## ADMINISTRATIVE REPORT

SUBJECT: Addition to the Vancouver Heritage Register and Designation - 2356 West 5th Avenue, 'The Blair House'

SHEET TITLE:  <b>INFILL HOUSE S &amp; W ELEVATIONS</b>	SCALE	PROJECT NO.
	1/4" = 1'-0" DRAWN AR	CHECKED AR & VZ DATE 28 APR 2004

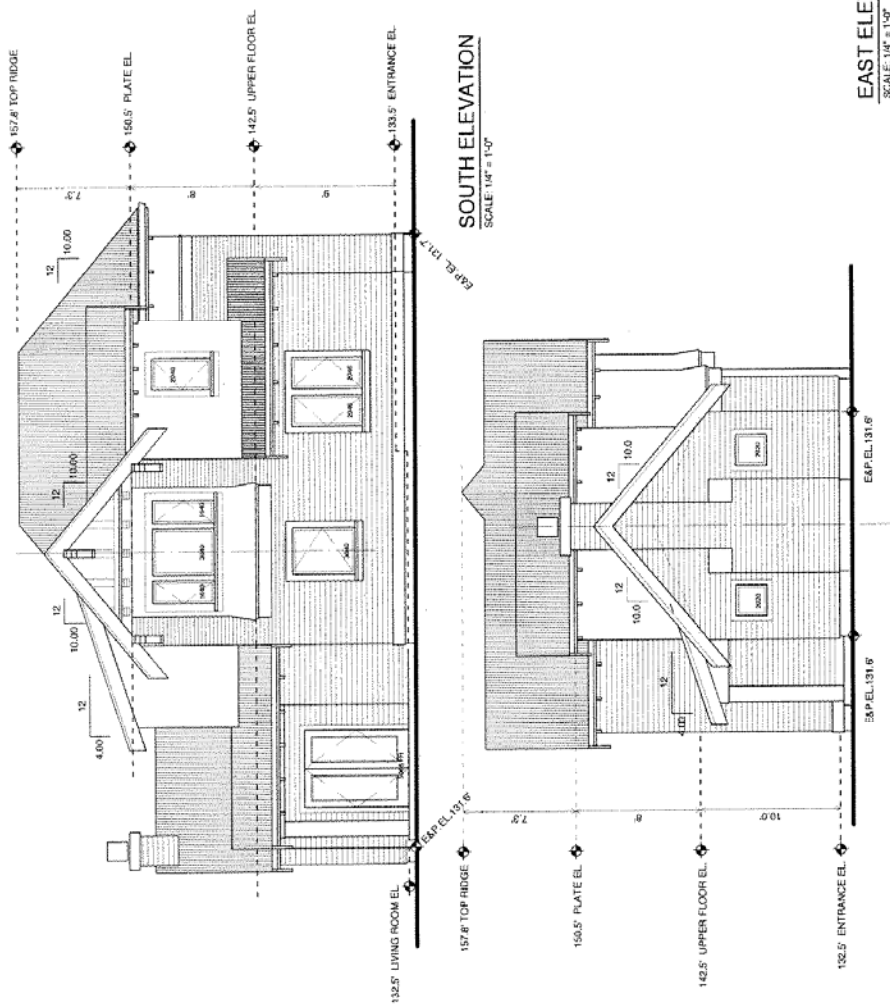
- (1) The infill building is too large, as are other infill buildings which have been approved and built in the neighbourhood. The size of such infill buildings is invasive and creates privacy impacts. The volume of the attic area on the infill is excessive and should be reduced.*

Infill buildings are permitted in the RT-8 zoning. The proposed infill building is 1,345 sq. ft. in area. New infill buildings approved in the neighbourhood range from approximately 1,100 sq. ft. (e.g. 2505 West 8<sup>th</sup> Avenue) to 1,433 sq. ft. (e.g. 2316 West 5<sup>th</sup> Avenue). While the infill building is within the 25.2 foot permitted height limit, conditions of the development application approval will require the attic volume and height of the roof of the infill building be reduced. Staff conclude the proposed infill building is within the range of densities commonly approved for infill buildings in the area, and that its design has adequately addressed privacy impacts, and is supported.
